What's Next Analysis of the US Magnesium Superfund Site
TAG (Technical Advisory Group)

William P. Johnson
TAG Advisor to FRIENDS of Great Salt Lake
09-18-2025

Figure 2. Groundwater hydraulic head contours (blue lines) determined from hydraulic head measurements in wells. Wells are indicated by blue circular symbols. Blue arrows denote general ground water westward toward Great Salt Lake.

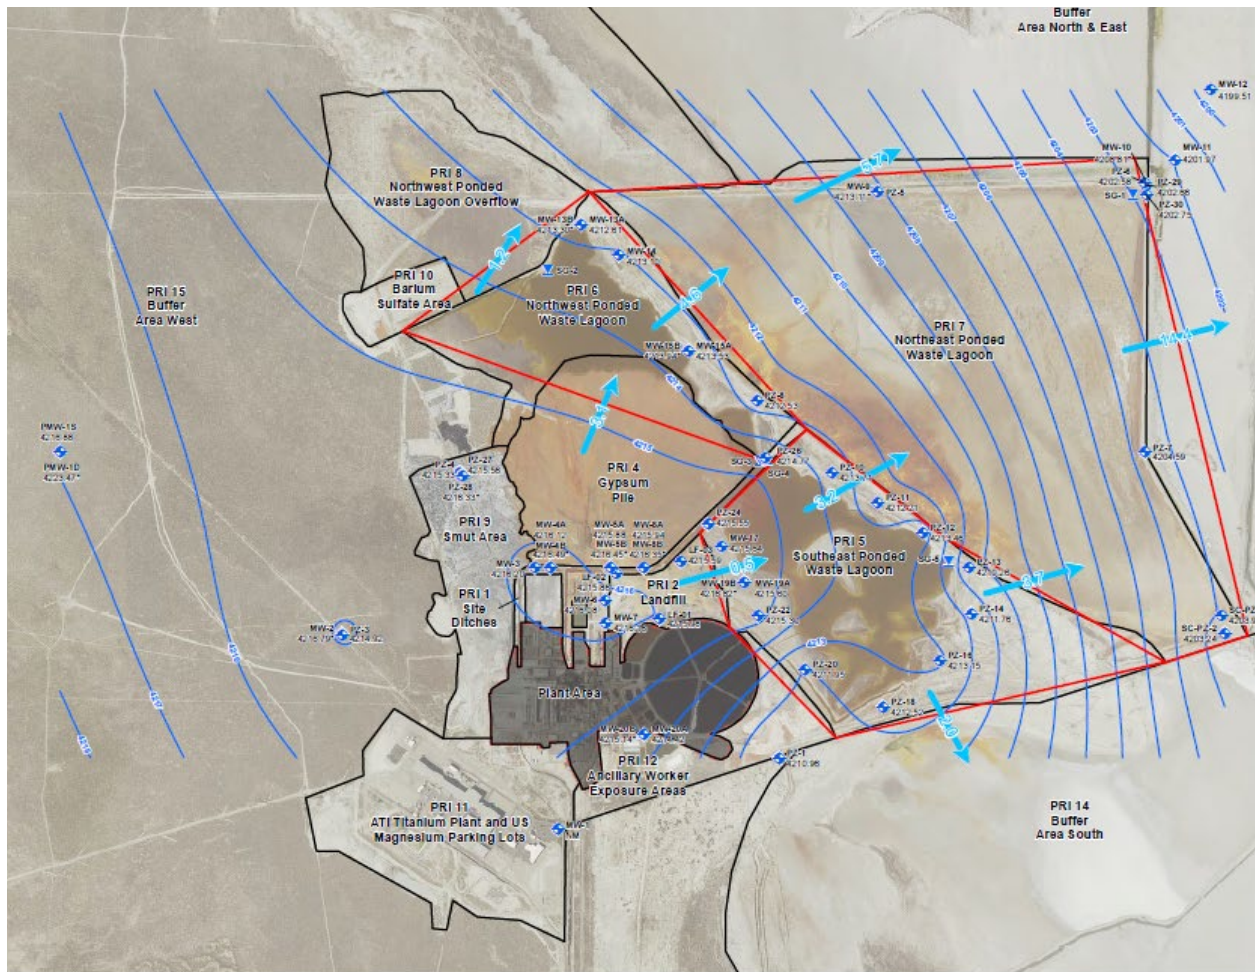
During operation, the site hydrology showed that groundwater was mounded under the site due to loading from waste discharge ([Figure 2](#)) ([Phase 2B Hydro Remedial Investigation Data Report, May 2020, Groundwater Discharge Permit Application by US Magnesium Corporation, 2018](#)). Groundwater mounding is indicated by the close blue circle under the CERCLA portion of the site southwest of the Gypsum Pile ([Figure 2](#)) which denotes a local high in the groundwater hydraulic head, from which groundwater would flow in all directions, but particularly eastward toward Great Salt Lake, as indicated by the larger blue arrows. This predominant flow is perpendicular to the contours (blue lines) that connect equal hydraulic head, as measured in wells. The fact that the hydraulic head contours are spaced closer together east of the Active Waste Pond ([Figure 2](#)) shows that a steeper hydraulic gradient exists east of the Active Waste Pond, and this can be expected to drive increased groundwater flow to the east toward Great Salt Lake.

Figure 3. Box diagram of sedimentary layers (strata) beneath the US Magnesium site.

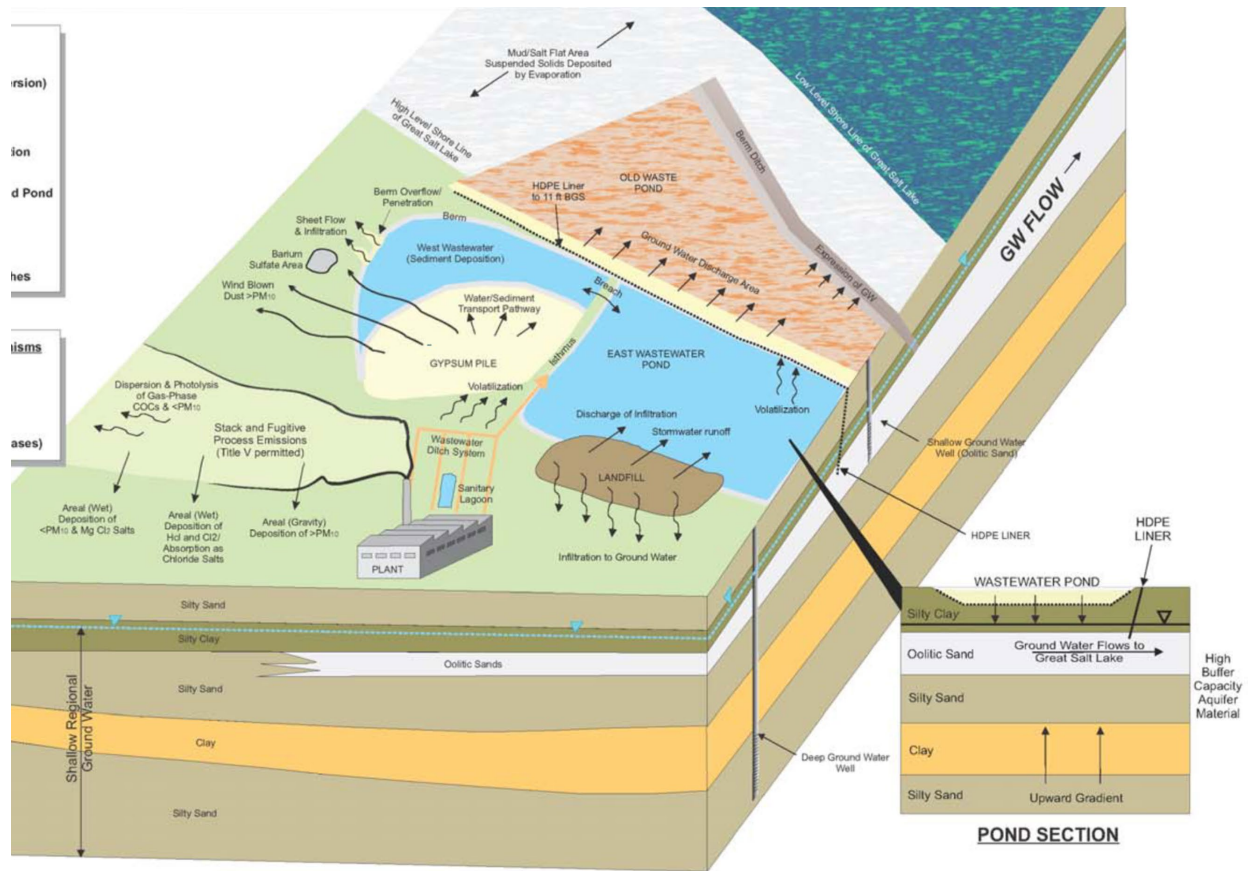
Equally concerning to the eastward groundwater flow is the fact that the flow is not expected to be uniform, but rather, higher and faster flow is expected in subsurface layers (strata) that are more permeable, with oolitic sands being a highly permeable layer (Figure 3) (Final Old Waste Pond Conceptual Site Model (OWB_CSM) Hydrologic Report, 2017). In addition to the oolitic sand layer, the fact that the acidic waste also dissolved channels into the underlying sediment (Figure 4) produces additional pathways for potential conveyance of contaminants outward from the site.

Since both a hazardous source (the US Magnesium site) and a likely pathway to Great Salt Lake exist, the need to determine the flux of contaminants outward (predominantly eastward) from the RCRA and CERCLA sites is urgent. This need is made more urgent by the fact that the planned barrier wall was designed to increase the waste pond footprint by a factor of three, which demonstrates that the waste balance performed by US Magnesium's consultants determined that two thirds of the discharged waste was leaving the site via unknown subsurface routes ([Final Old Waste Pond Conceptual Site Model \(OWB_CSM\) Hydrologic Report, 2017](#); [Groundwater Discharge Permit Application by US Magnesium Corporation, 2018](#); [Retrofitted Waste Pond Phase 1 Basis of Design Report - US Magnesium Facility, Revision B, 2019](#)). Finally, the fact that the barrier wall was implemented as a surface berm, never having been completed with a clay core notched into the underlying clay ([Figure 3](#)) as originally planned, and the fact that several
